HESS OIL VIRGIN ISLANDS CORP.

Re: St. Croix Alumina Site Administrative Order Docket No. RCRA-0202001-7301
Response to November 1, 2021, EPA Comments to the Phase 1 Natural Source Zone Depletion
Assessment Report
EPA Facility ID No. VID090302084

Re: Response to Technical Review, Phase 1 Natural Source Zone Depletion Assessment Report, St. Croix, U.S. Virgin Islands, St. Croix Alumina Site, Dated September 2020. EPA ID Number VID090302084

Gas gradient well design schematic

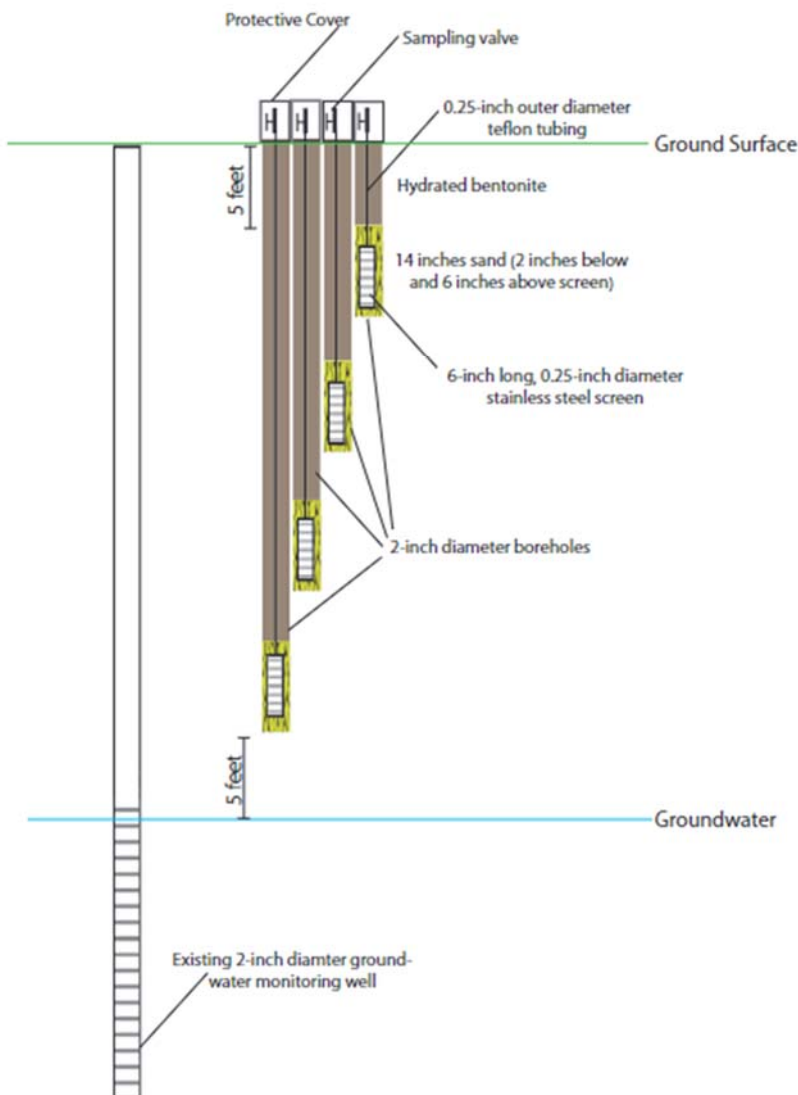
General Comment 1: The presence of methane in soil gas from well headspace near the groundwater surface may not be representative of gas compositions in the near surface of the site at the top of the vadose zone as noted in EPA's previous comments on the LNAPL Natural Source Zone Depletion Work Plan. St. Croix Alumina Site, St. Croix, dated April 2021 (Work Plan). This is because of the longer residence times in the vadose zone for methane gas to be exposed to oxidation. Well casings, as opposed to natural conditions, are open conduits for the travel of methane to near the surface. As such, the Phase 2 scope of work needs to use Dynamic Closed Chamber (DCC) methods to verify the presence of methane in surface soil gas and to identify key locations for further study. The DCC method using a more extensive grid sampling approach is commonly used as a screening method at sites followed by the use of more definitive methods like E-Flux and/or some periodic monitoring events using DCC and soil gas probes at key locations over a more extended period of time. Once key monitoring locations are identified E-Flux can provide time weighted results over weeks and results directly corrected for atmospheric carbon influences (Bioremediation and Sustainable Environmental Technologies, May 2017 by R. Ahlers, A. Pennington, J. Zimbron, C. Jones "Field Comparison of Two CO₂ Sorbent Trap Methods and Dynamic Closed Chamber Method for Soil Flux Measurement."). The use of gradient methods that use soil gas probes installed at multiple depth intervals may also need to be considered where significant portions of the site are covered by concrete or heavy vegetation.

- We agree that gas gradient methods provide a line of evidence to support data collected from a DCC assessment during Phase 2 works. For this reason, four locations of nested (multi-level) soil gas probes adjacent to existing monitoring wells were proposed for incorporation into the Phase 2 program of works (see Figure provided as **Attachment B** and design schematic below).

Attachment A – Revised Figure 2

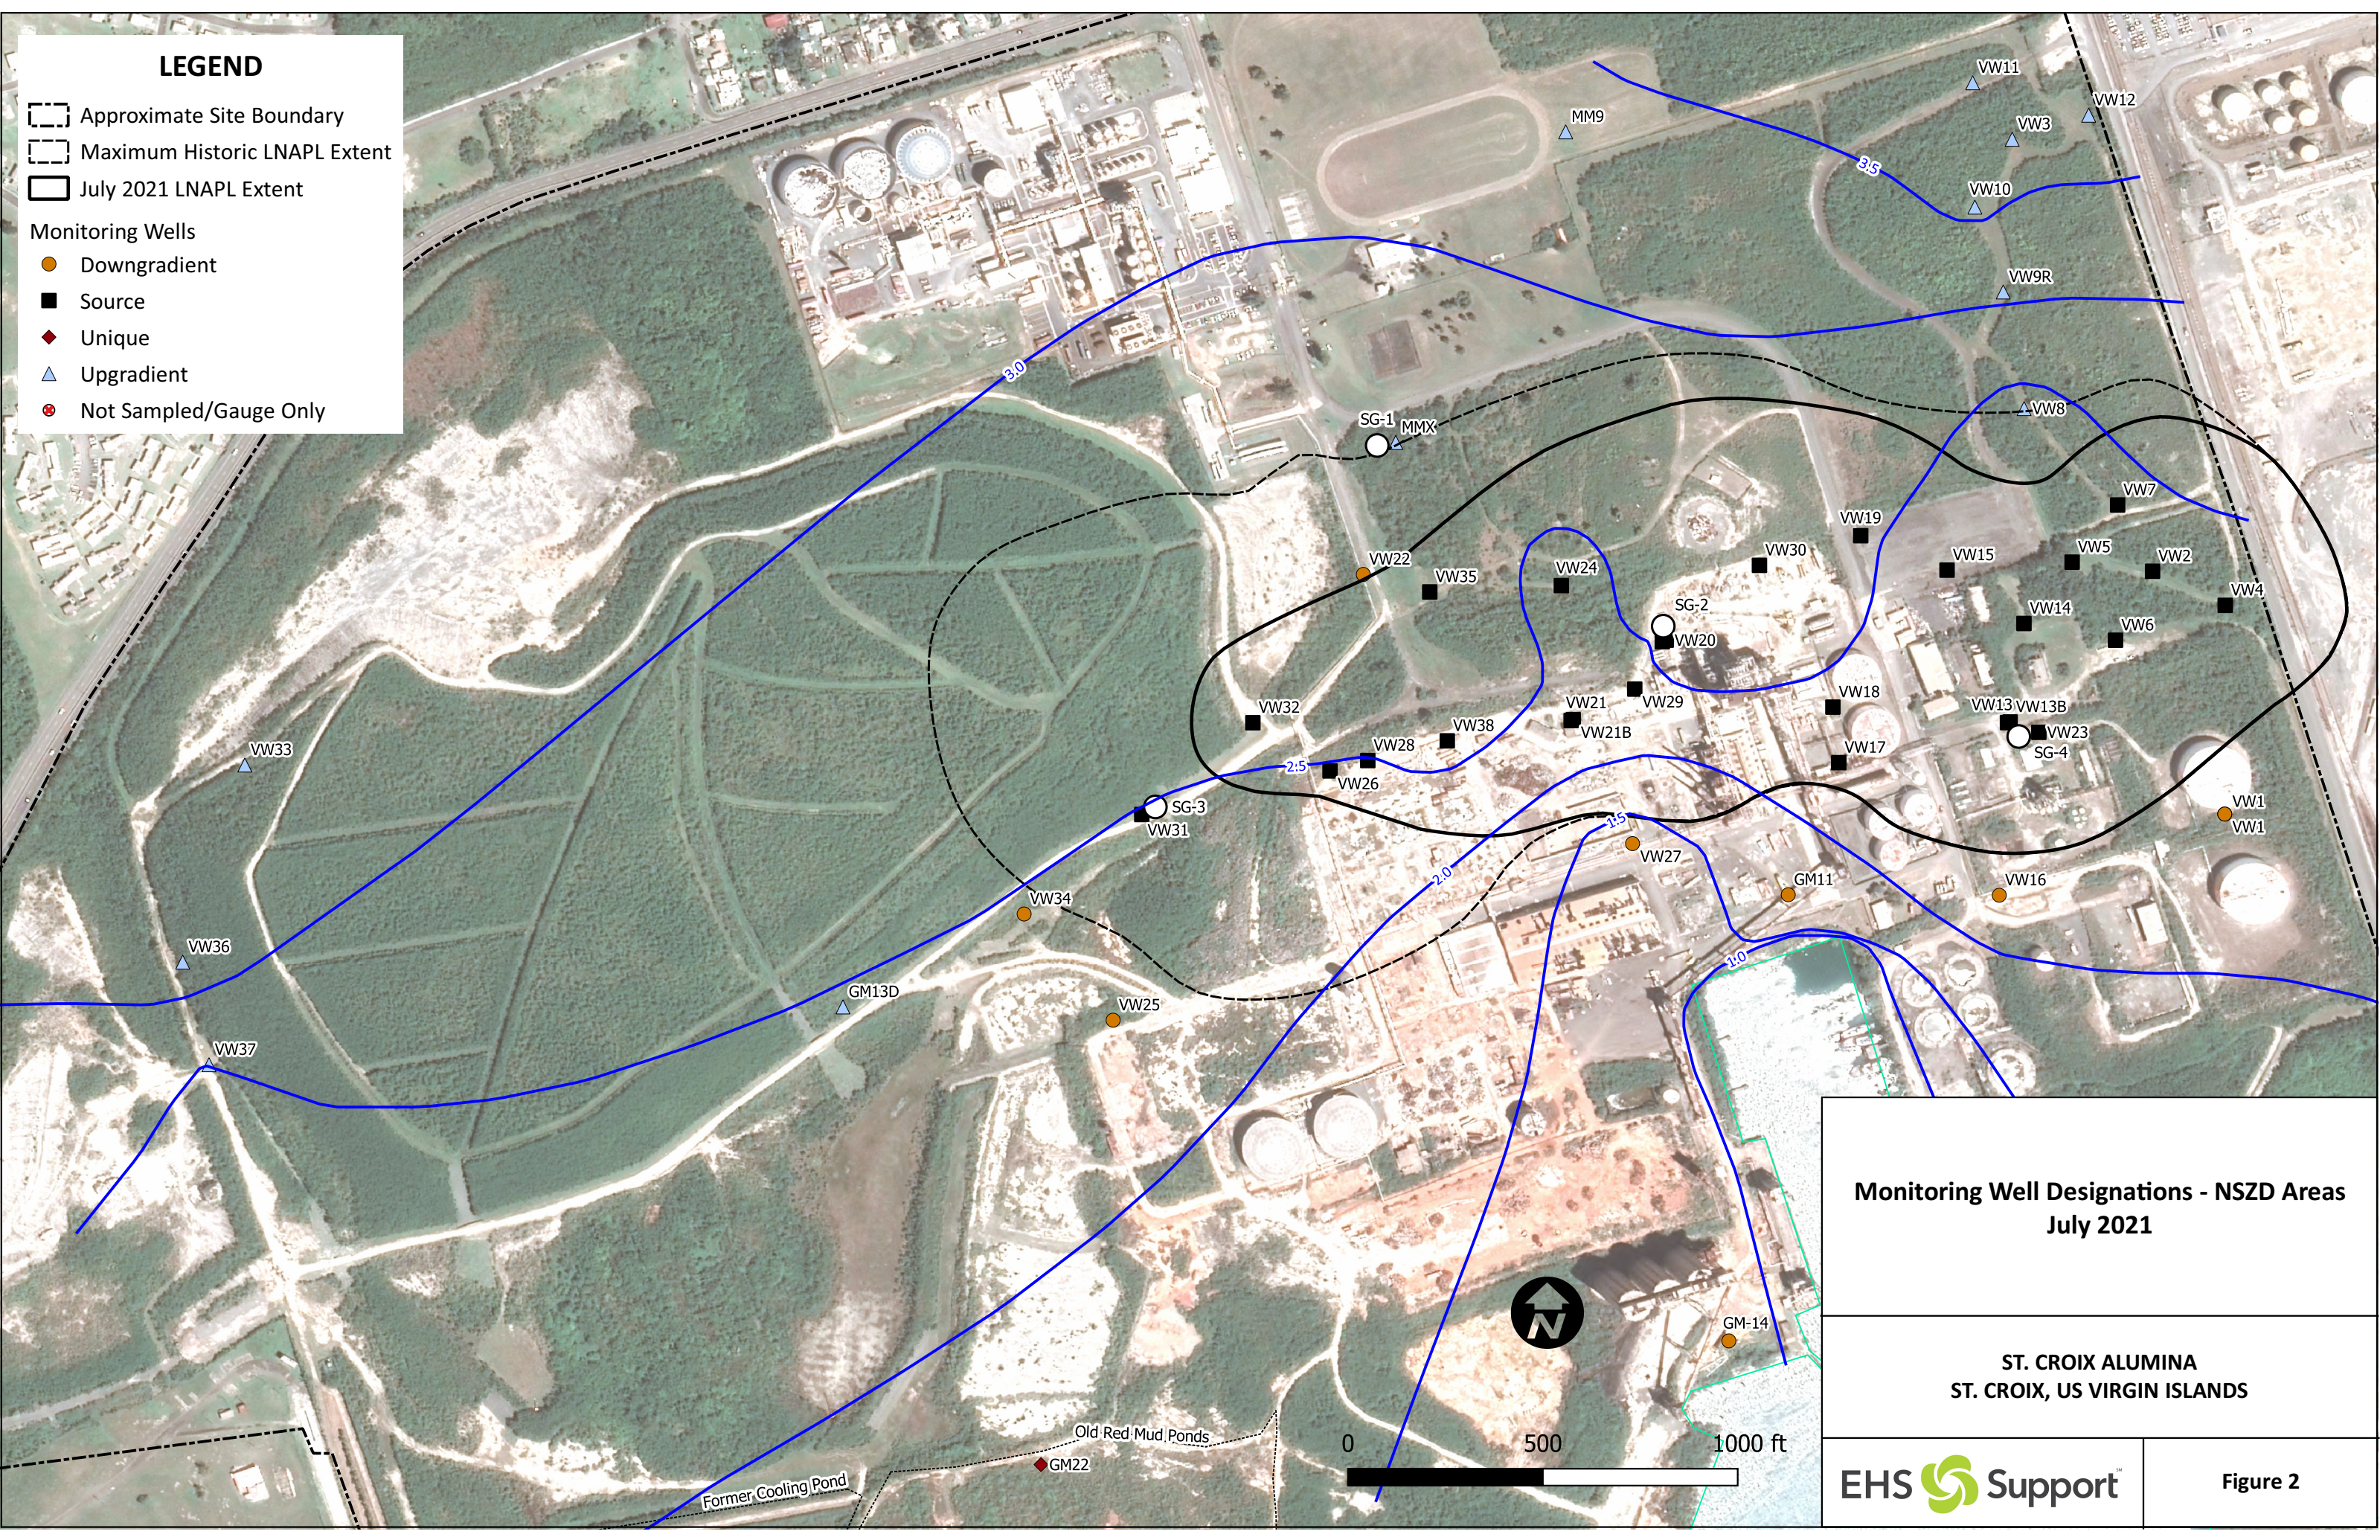
Specific Comment 5: Section 5.2, Page 11 and Figures 2, 4 and 5-3: A reference piper plot showing the general ranges in values for various water types discussed in this section is needed for comparison purposes. Also, background wells need to be clearly identified on Figures 2 and 5-3. Finally, many of the supposed down gradient wells shown in Figure 2 appear to be in the source area based on the light non-

aqueous phase liquid (LNAPL) thickness plot provided in Figure 4. Please provide an explanation as to why these wells are considered down gradient when they appear to be in the LNAPL plume.

Response to Specific Comment 5: *Comment is noted and the report will include a reference piper plot to guide the reader and clear labelling of background wells. It was also discussed on the conference call that EHS Support would include additional text on the criteria used for selection of background, source and downgradient wells for the purposes of this assessment and general discussion of NSZD results.*

The criteria for selecting upgradient wells are those located hydraulically up- or side-gradient to the LNAPL plume. Source area wells are those that have measured LNAPL. Downgradient wells are those that are immediately adjacent to the LNAPL affected area or hydraulically downgradient. Whereas these areas are generally consistent, some designations may change between monitoring events. The figure has been updated to reflect the July 2021 area designations as requested. Figure 2 has been updated and provided as Attachment A.

Attachment B – Revised Figure 11

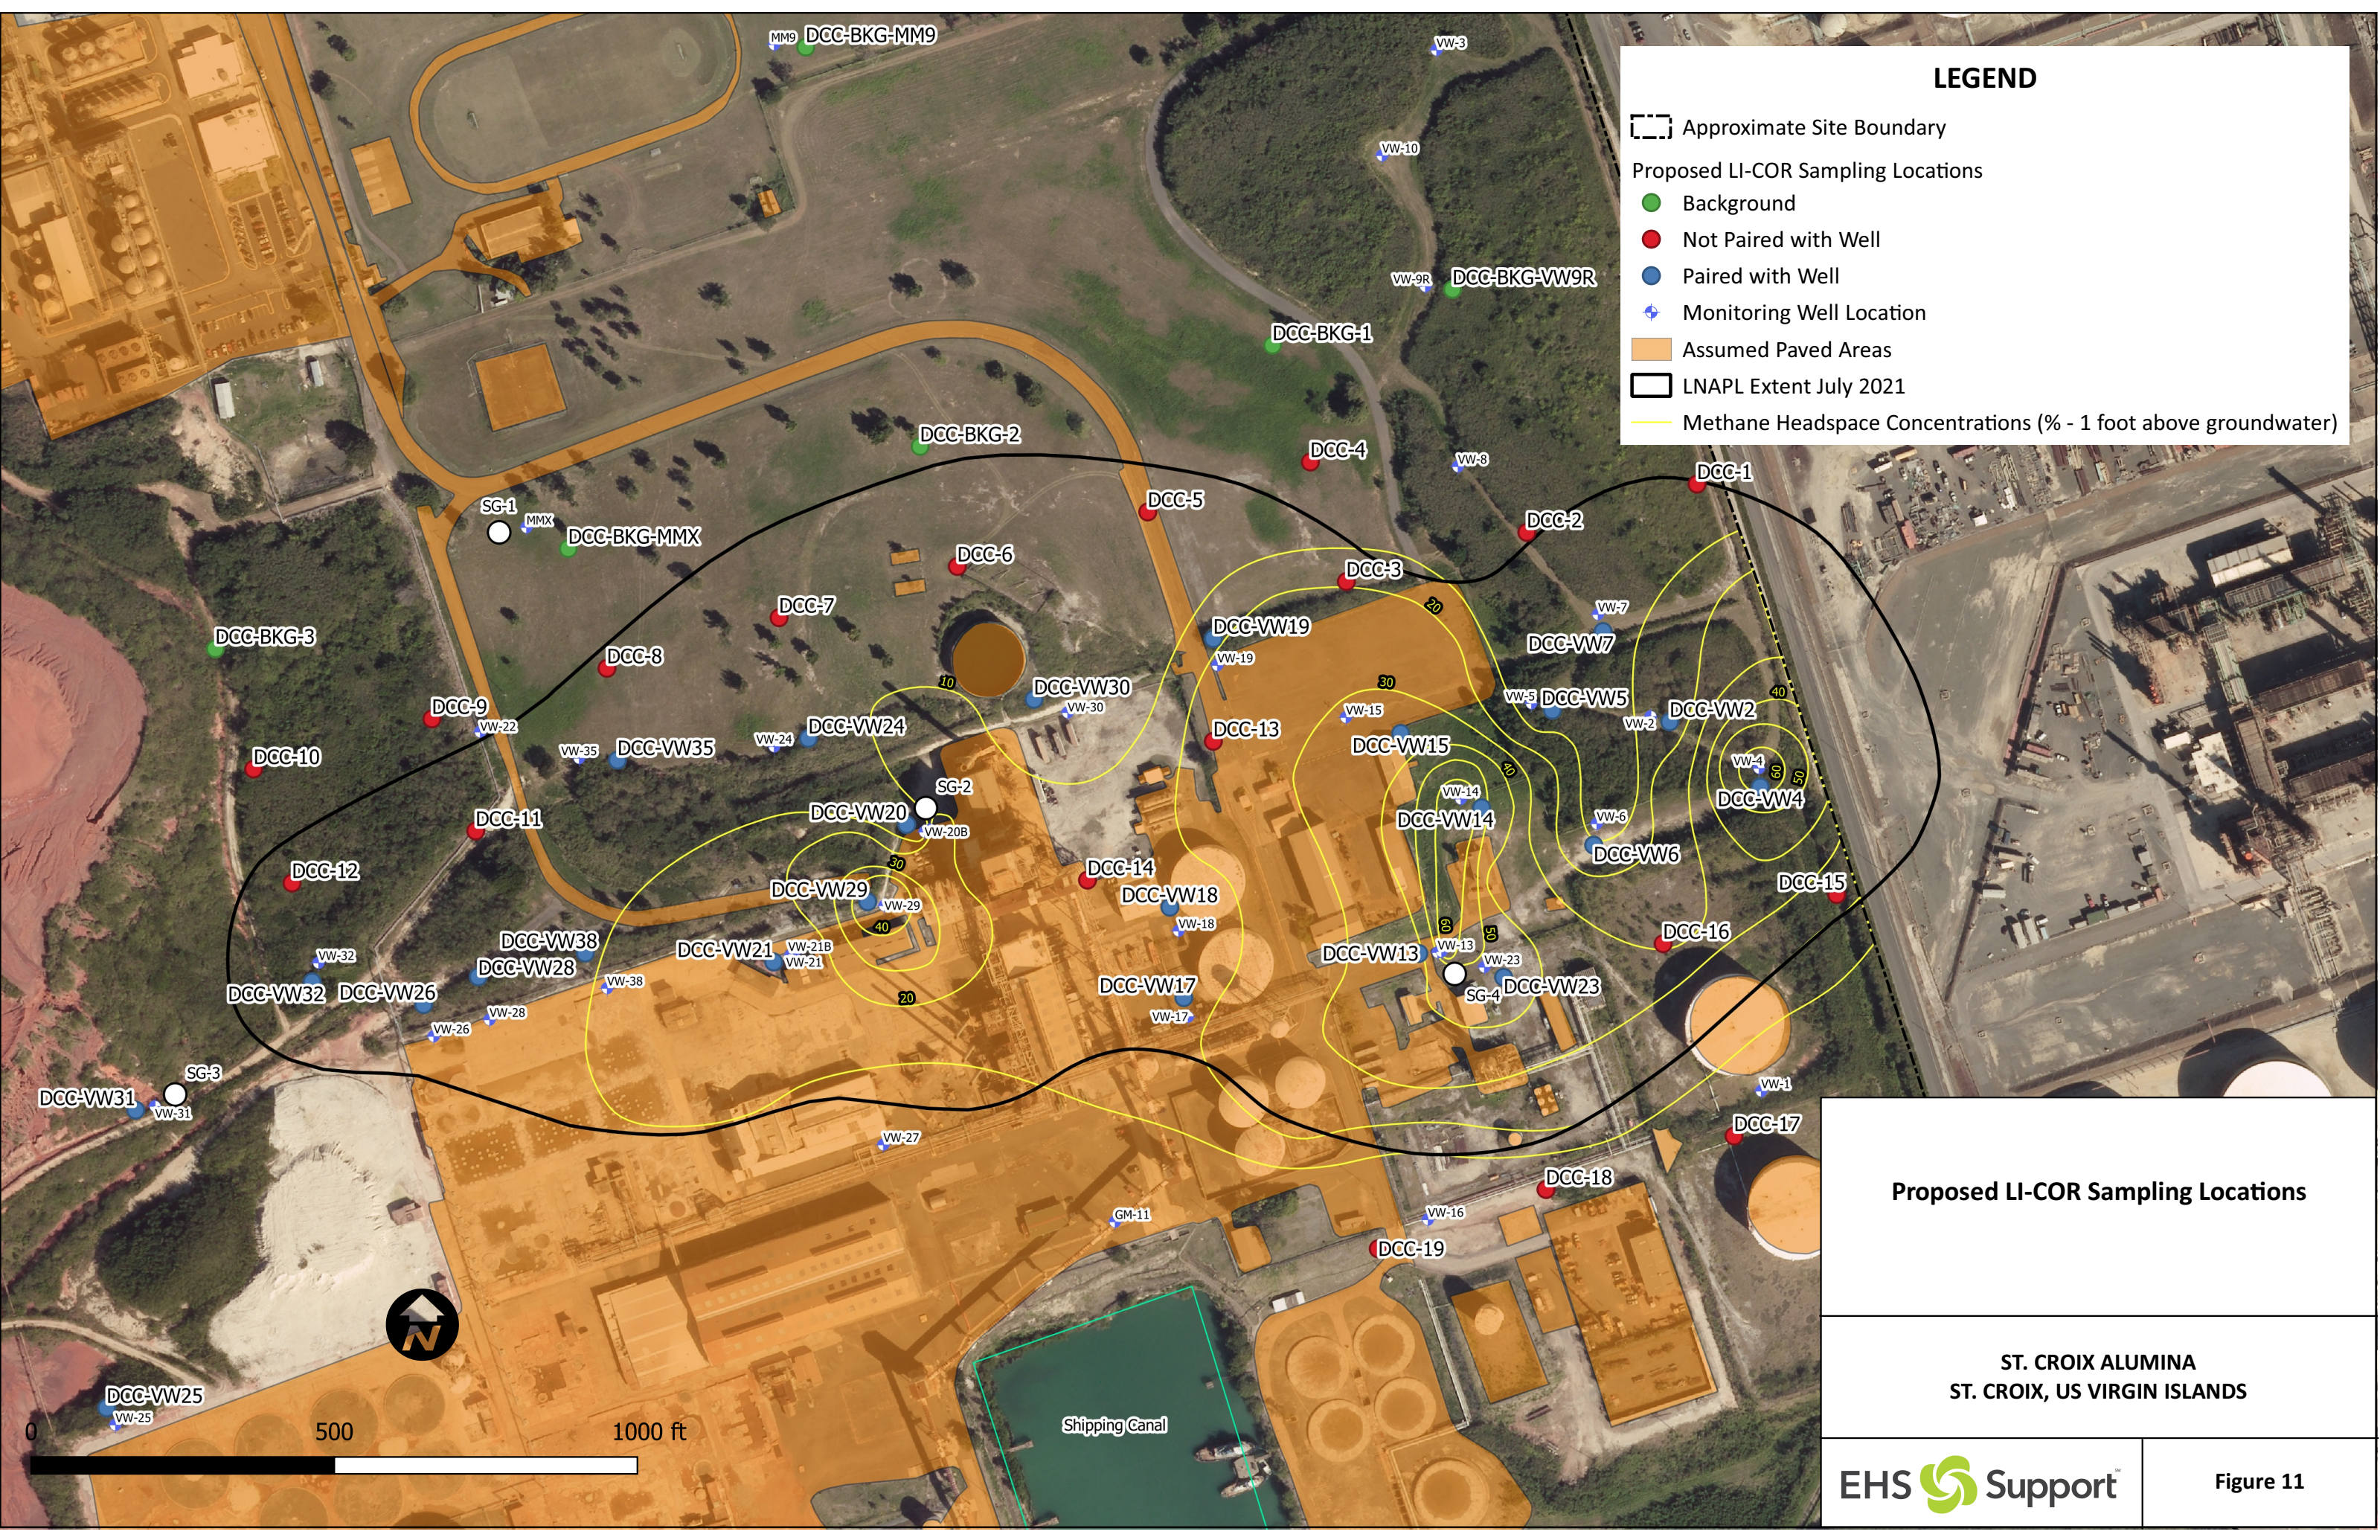
Specific Comment 13: Section 8, Table 8-1, Page 37: It is unclear if adequate background wells have been identified. Additional measurement of potential impacts from atmospheric CO₂ using E-Flux and or the Barium carbonate method are needed before it can be concluded that results are representative of influx from NSZD reactions. Revise the Phase 2 scope of work to address this issue

Specific Comment 15: The grid proposed for collection of DCC data is too widespread and misses many of the expected hot spots. In addition, sample locations do not twin many of the wells where data was collected during Phase 1. A tighter grid located primarily near the best producing wells at the site are needed to assess NSZD. In addition, much of the site is paved or highly vegetated and may be better suited for soil gas probes. Please revise the Phase 2 scope of work to include use of a dynamic work plan approach and multiple soil gas measurement flux methods and probes for comparison purposes.

Response to Specific Comment 13: *As noted above, additional background DCC locations have been added to the proposed sampling program. Given that the DCC method comprises a systematic program of testing comparison of background to source area concentrations will allow elimination of both natural and atmospheric sources of methane and carbon dioxide. A revised Figure 11 is provided as **Attachment B** showing additional DCC deployment locations and indicating proposed soil gas gradient well locations.*

Response to Specific Comment 15: *The sampling grid has been revised to incorporate additional DCC sampling locations adjacent to wells and includes additional background sampling locations, and is provided as **Attachment B**. As noted in the Phase 1 report, additional sampling locations will be included at locations to be determined in the field. This will be based on (a) opportunities to access additional*
